**No. 87-3**

## Motor Mount Breakage on MCM 175, 200, 205, 230, 260, 350 Magnum and 330 TR/TRS Engines

**Cast Mount Bracket Part No. 79550A1**

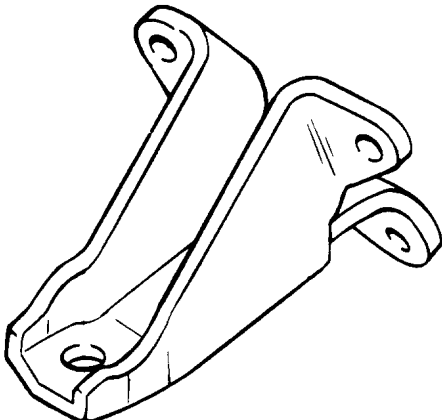
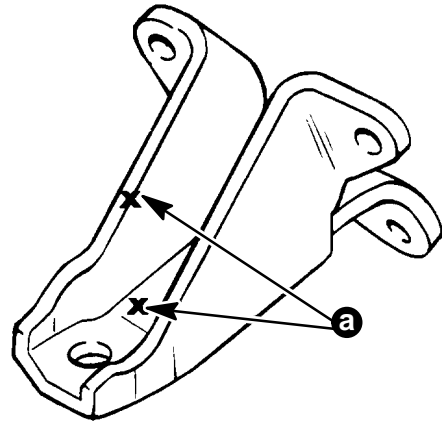
MerCruiser Service has received a few isolated reports of motor mount breakage on MCM V-6 and V-8 engines, similar to those on 454 Magnum engines. (Refer to Service Bulletin 86-24). If a customer experienced motor mount breakage on these models, both of the stamped steel mount brackets should be replaced with cast iron mount brackets Part No. 79550A1. Unlike the 454 Magnums, this is not a recall and should be handled on an individual basis according to our warranty policy.

Due to the severe conditions under which they are operated, the 350 Magnums and the 330 TR/TRS engines will be equipped with cast mount brackets as standard equipment starting immediately. The other V-6 and V-8 engines will receive a new stamped mount made of a new material. These mounts can be identified by an "X" stamped in one of two places.
